**Addendum No. 1**  
**March 6, 2025**

Project: Brandon Valley Middle School Addition  
Brandon, South Dakota  
Project #3090

Architect: Architecture Incorporated

**SITE PLAN - ELECTRICAL**  
 SCALE 0 20 40 60 80

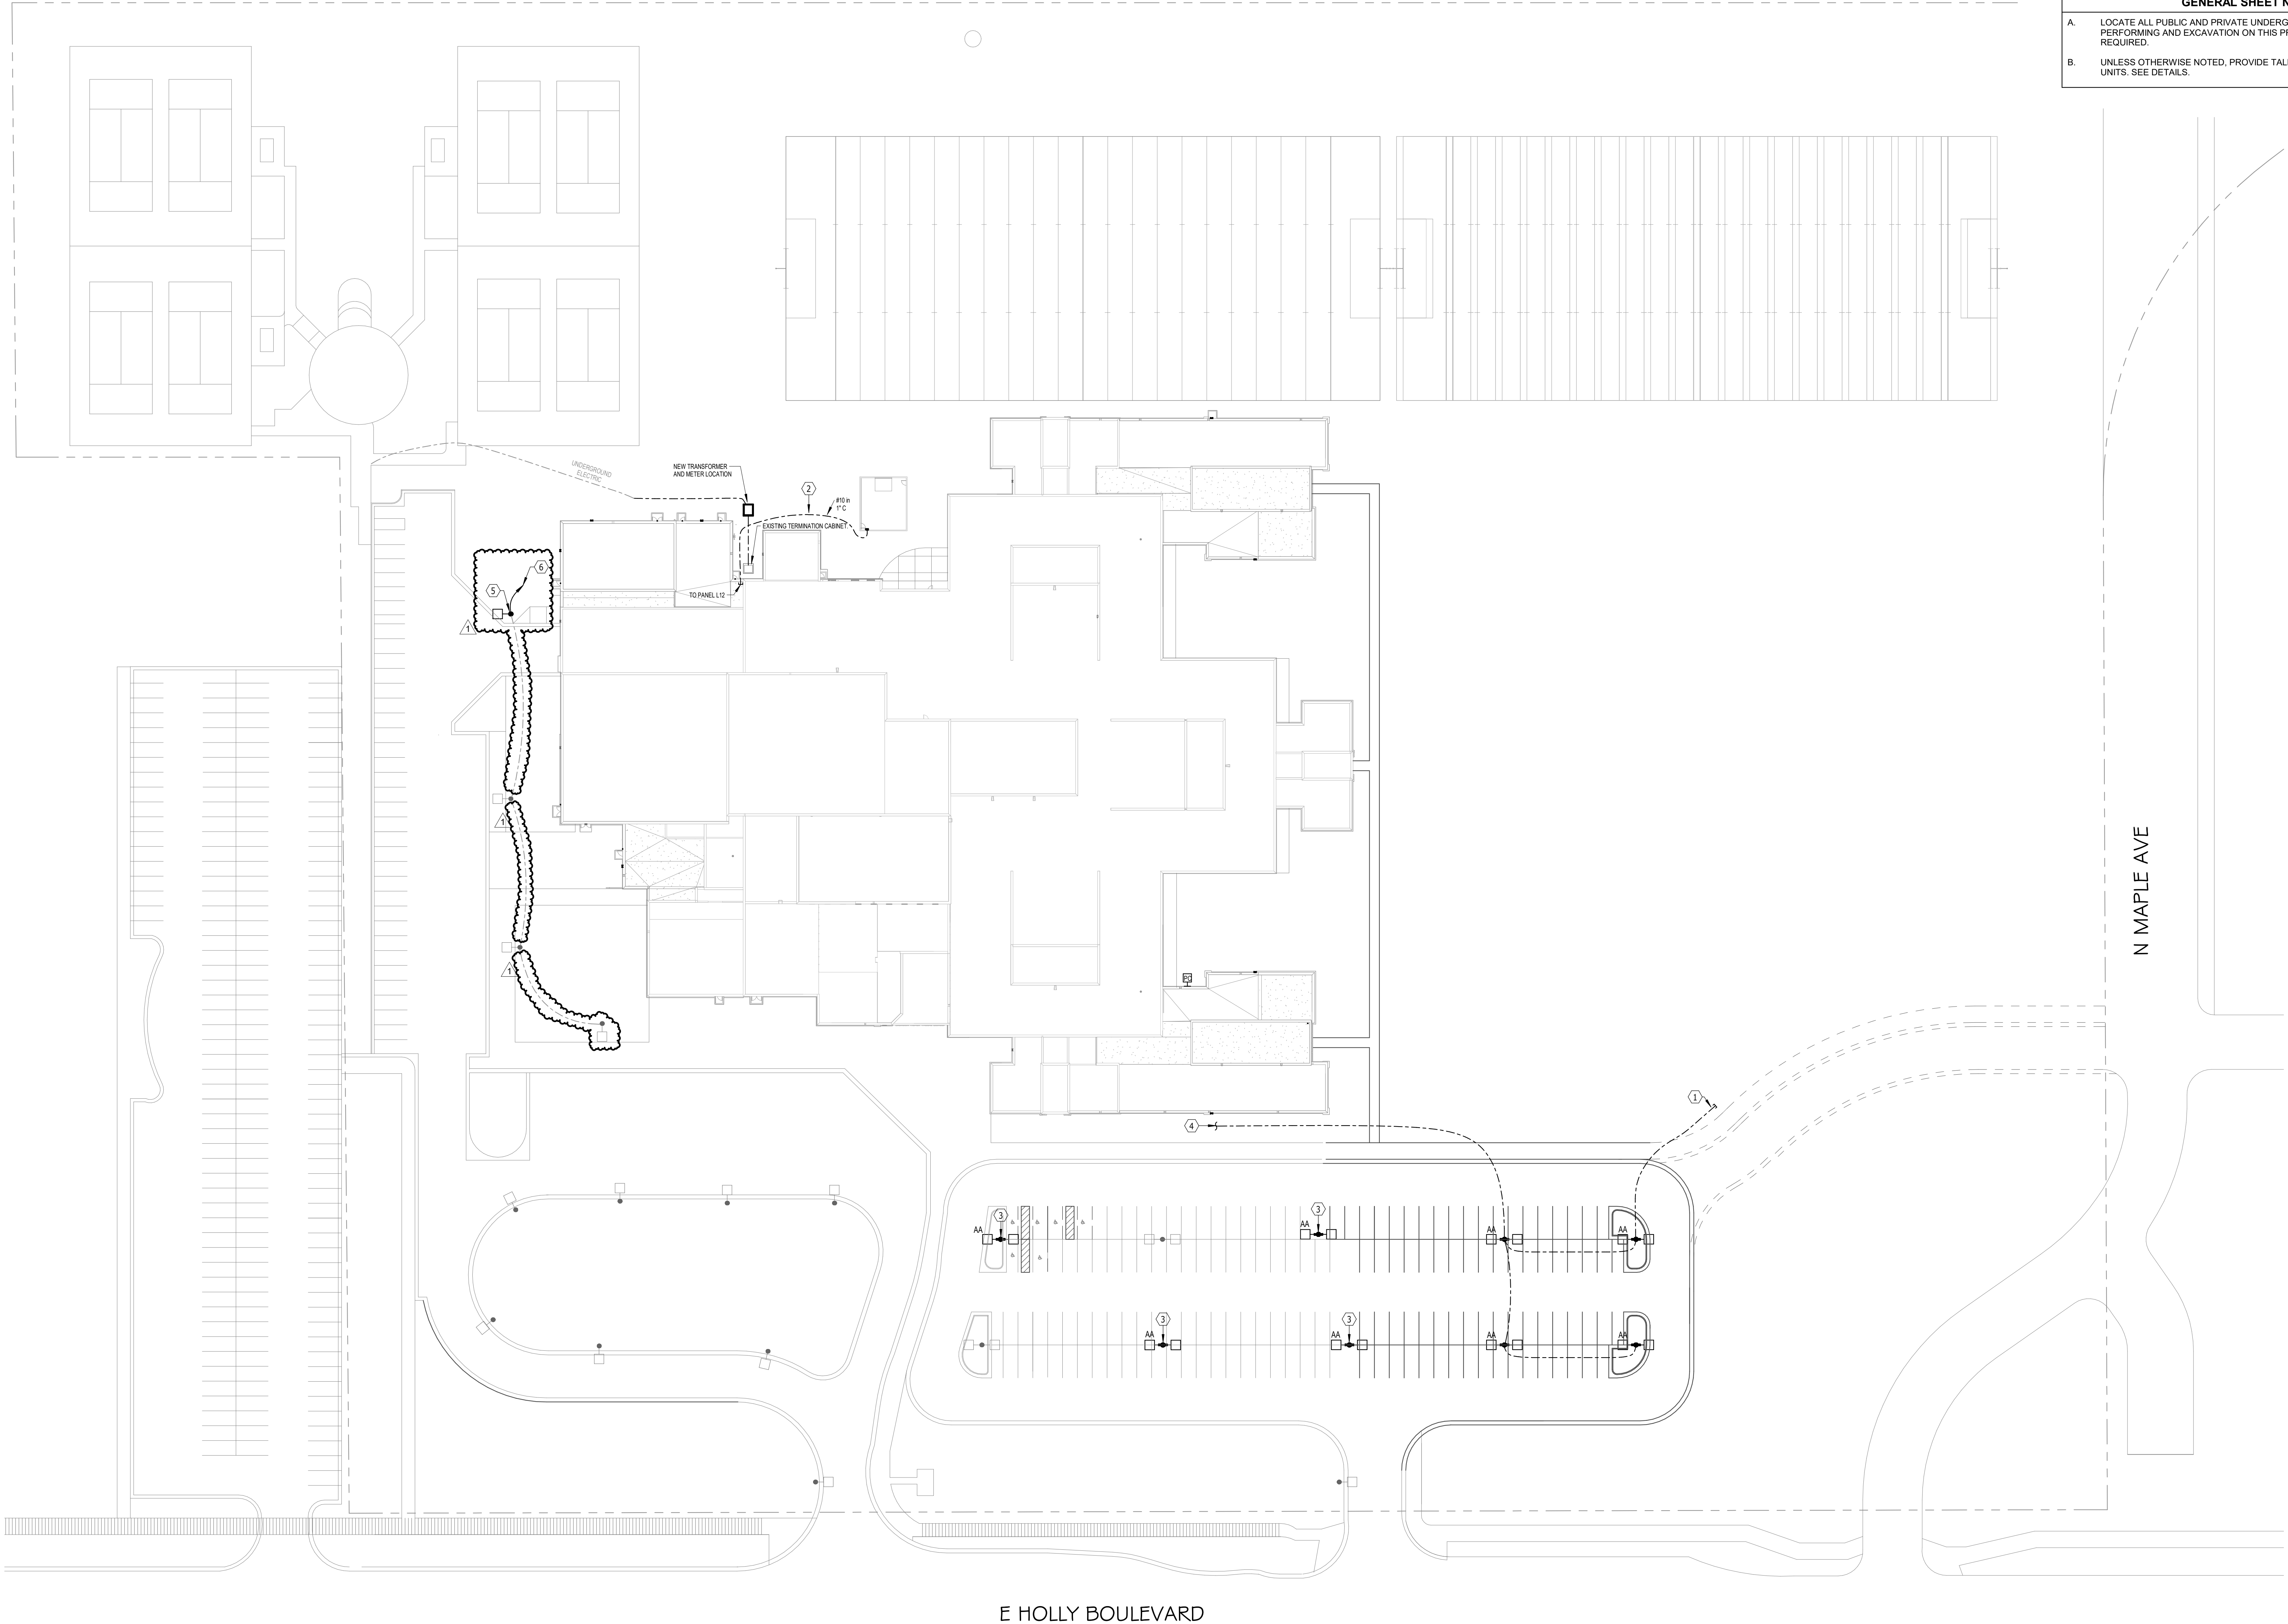
- 2) SHEET 9.11 - SITE PLAN - ELECTRICAL
  - a) Add Electrical Note #5 that reads “DEMO POLE BASE AND REPLACE WITH NEW. POLE BASE TO MATCH EXISTING. REMOVE AND REINSTALL POLE AND LIGHTING UNIT.”.

- b) Add Electrical Note #6 that reads “PROVIDE NEW HOMERUN TO PANEL H5 (#10). RECONNECT TO SAME CIRCUIT AND CONTROLS AS WAS ORIGINALLY CONNECTED AT REMOVED UNDERGROUND JUNCTION BOX”.

- c) Reference *revised* electrical drawing Sheet 9.11, revision dated 3-6-2025, attached to the end of this addendum for additional details associated with the pole lights.

9.20

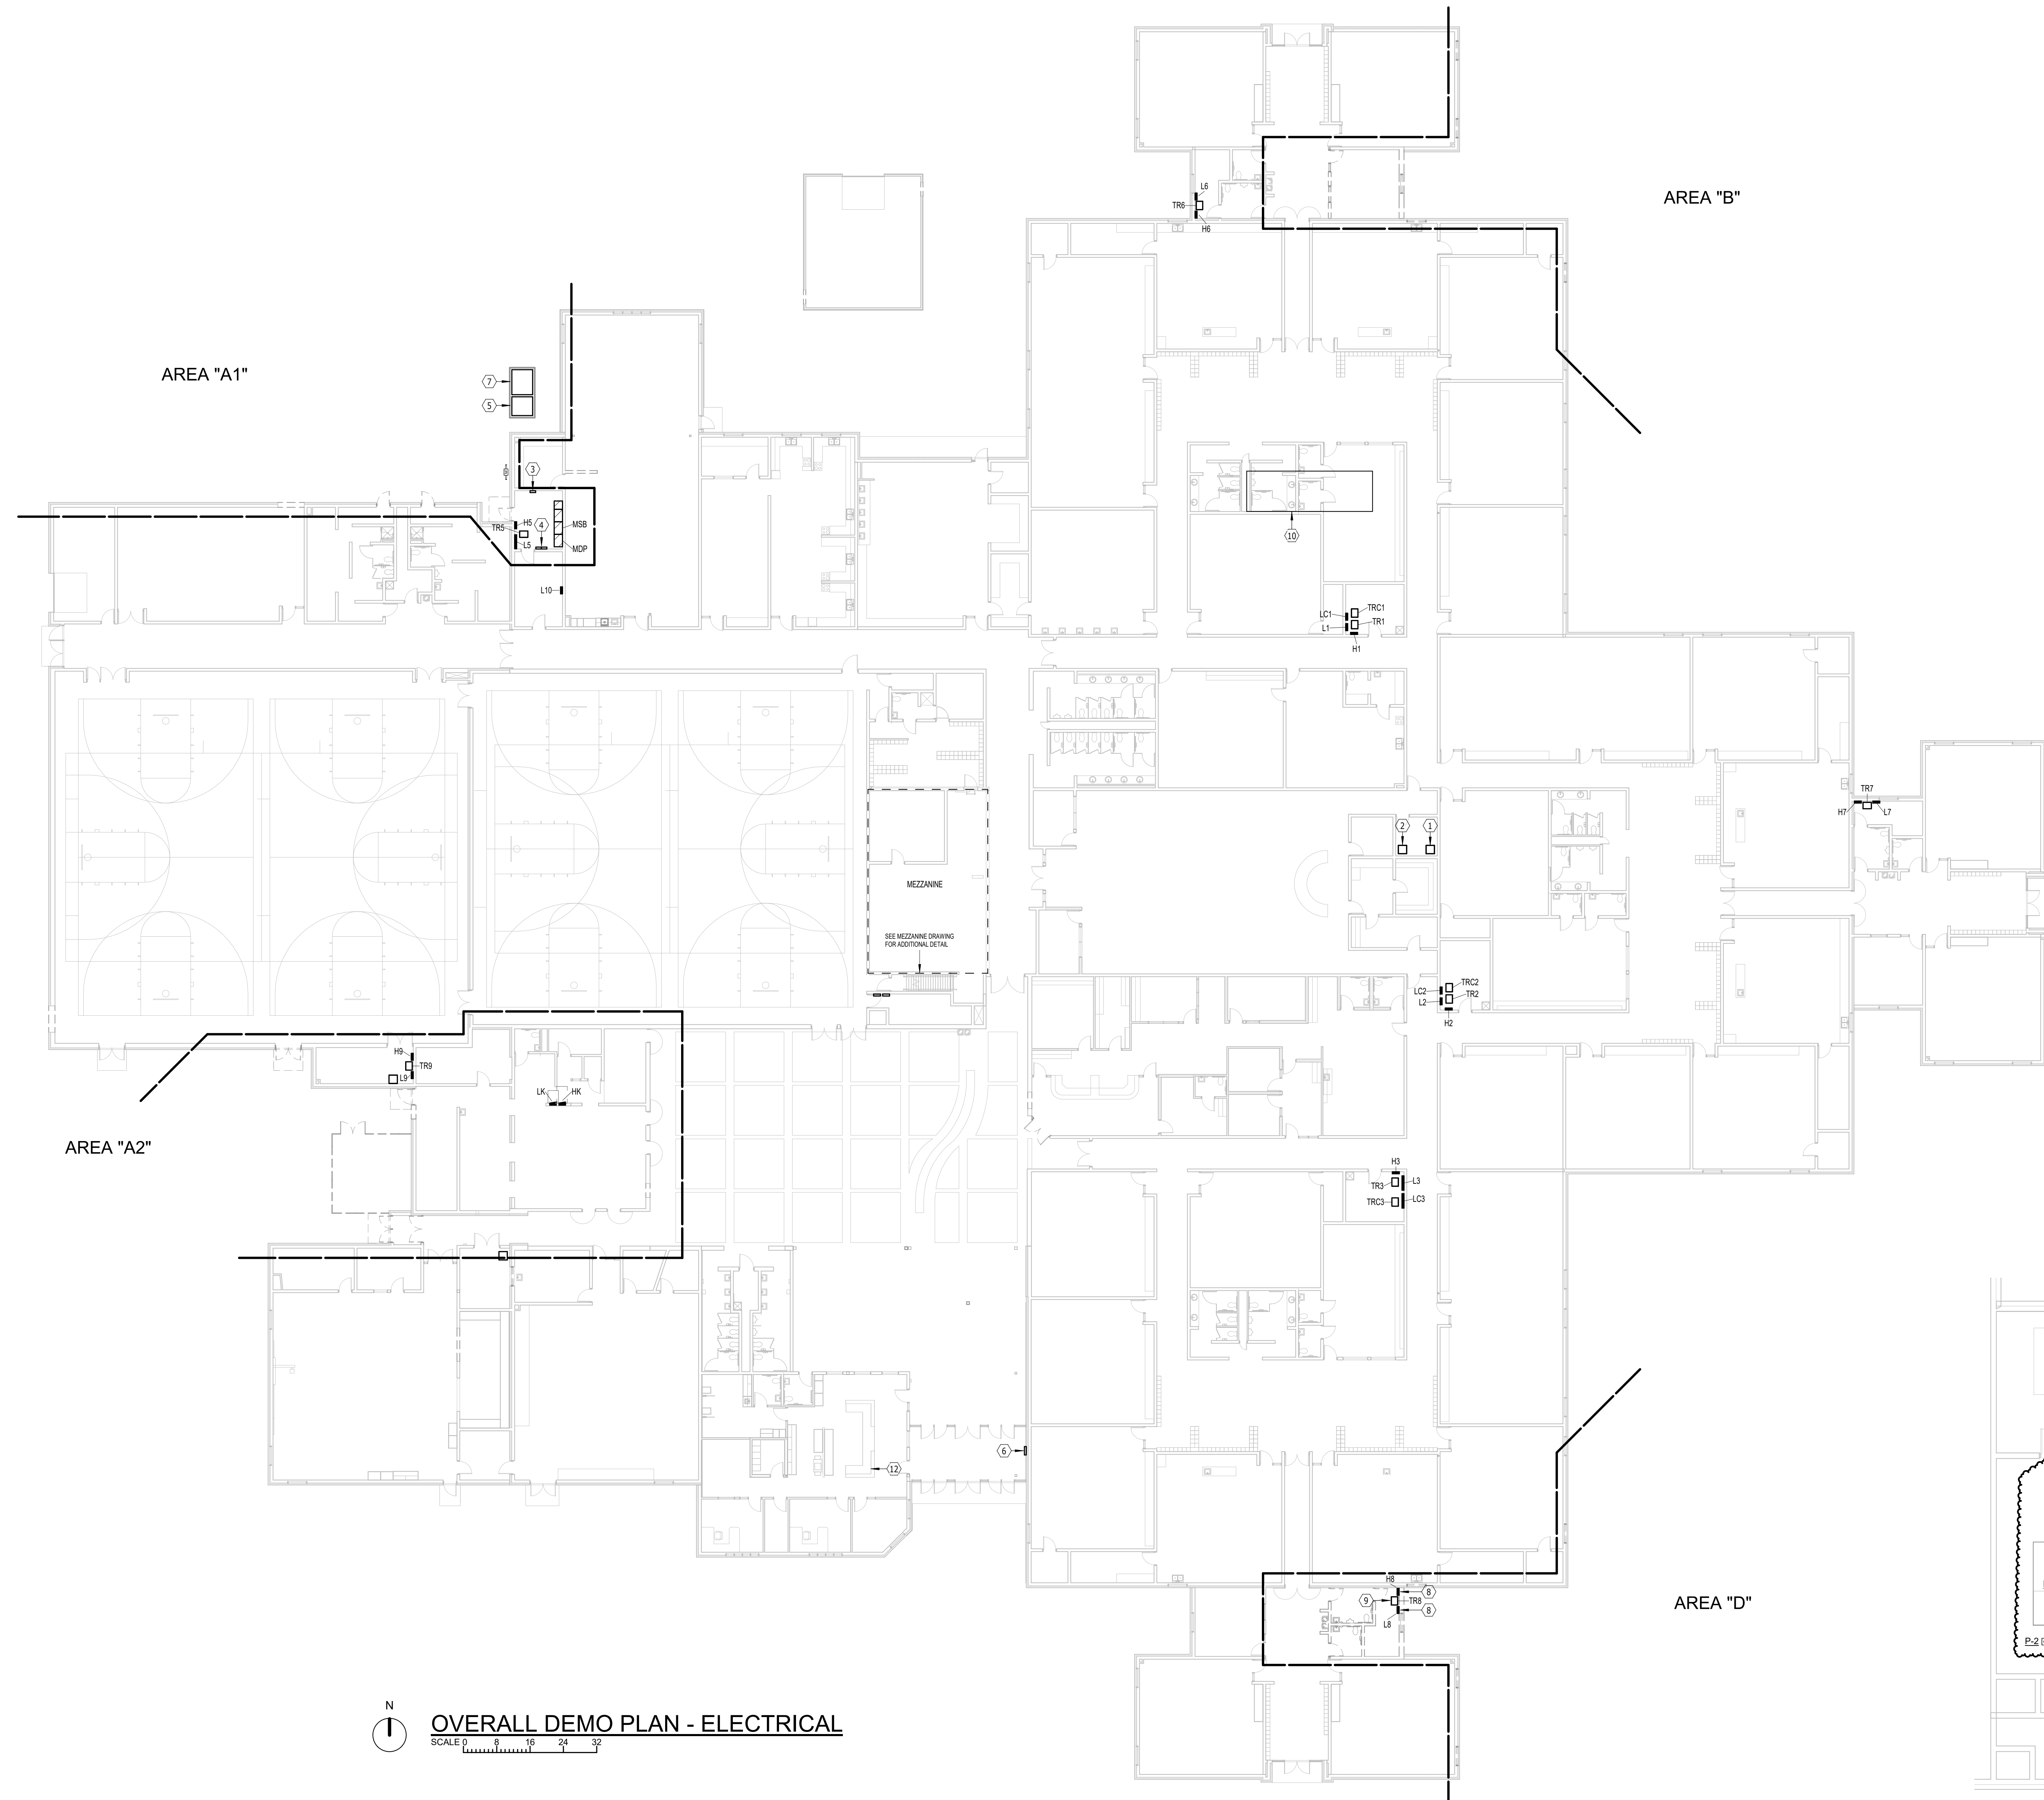
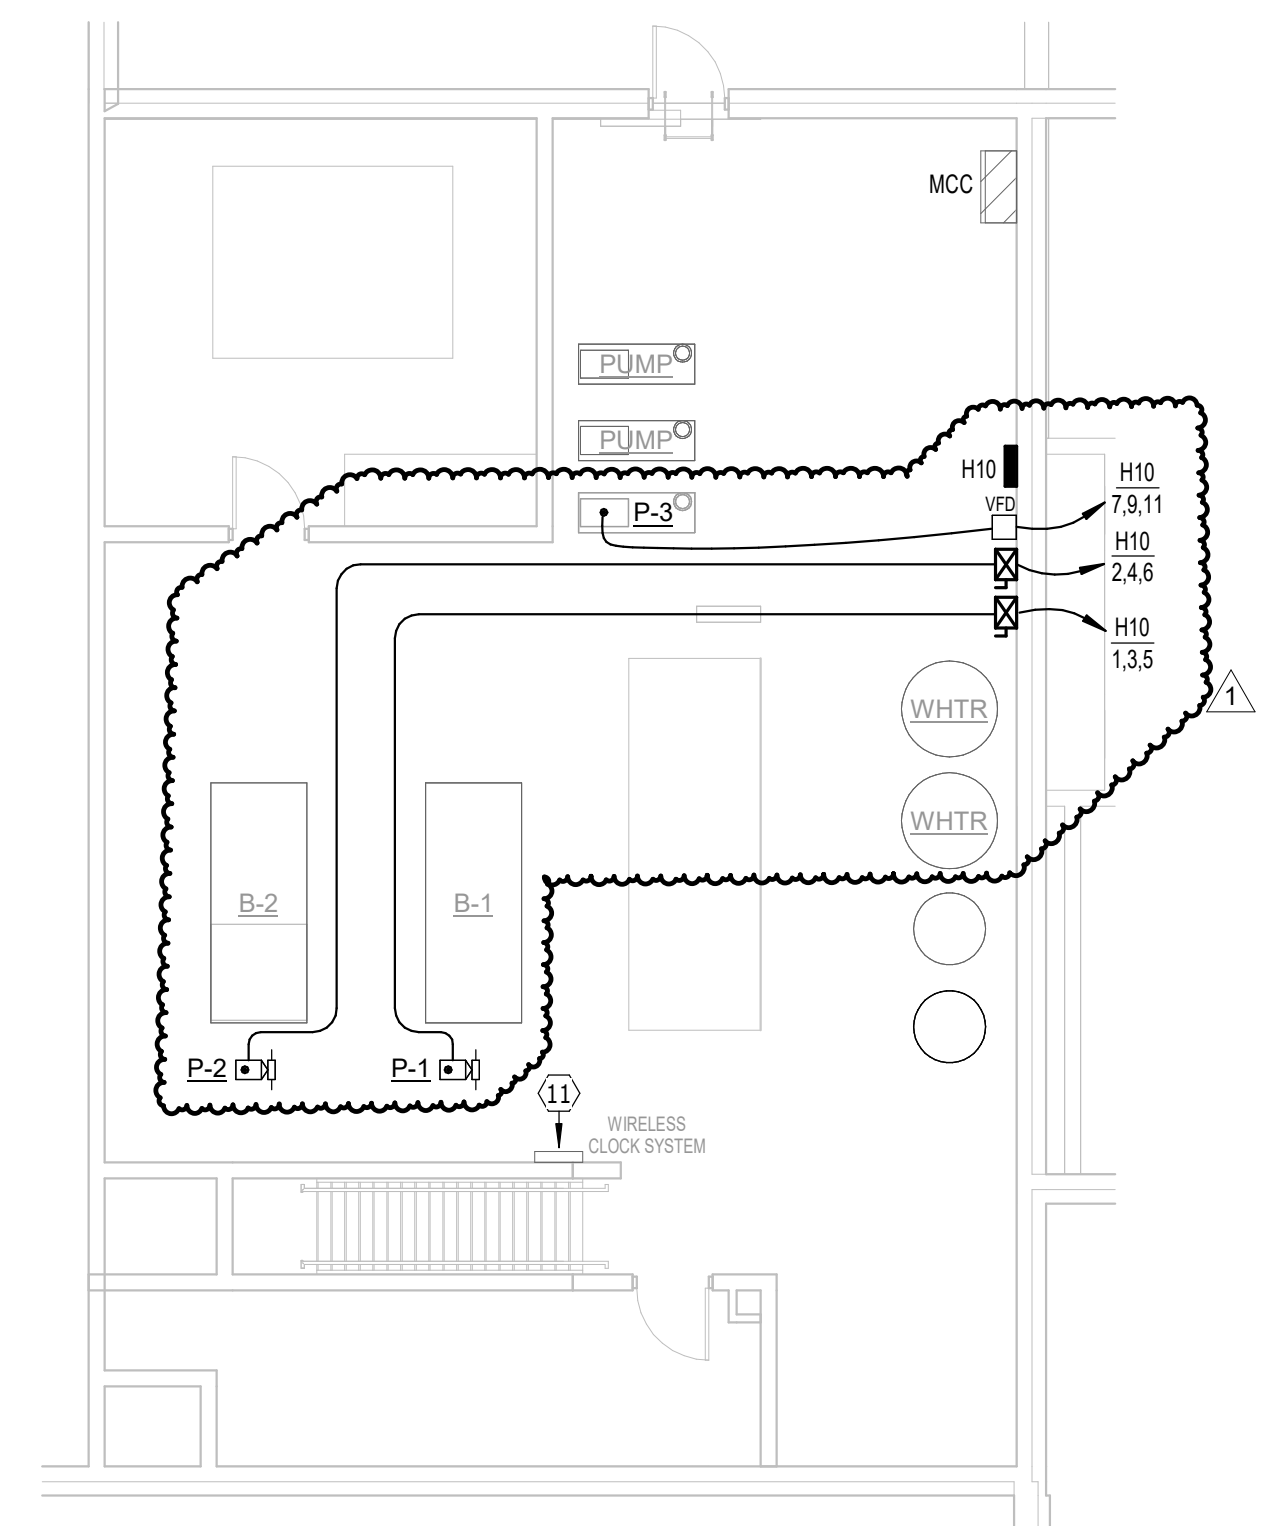
- 3) SHEET 9.20 – FIRST FLOOR DEMOLITION PLAN – AREA A1 & A2 ELECTRICAL
  - a) Reference *revised* electrical drawing Sheet 9.20, revision dated 3-6-2025, attached to the end of this addendum for revised locations of Panel H10, VFD and 2 combo starters.
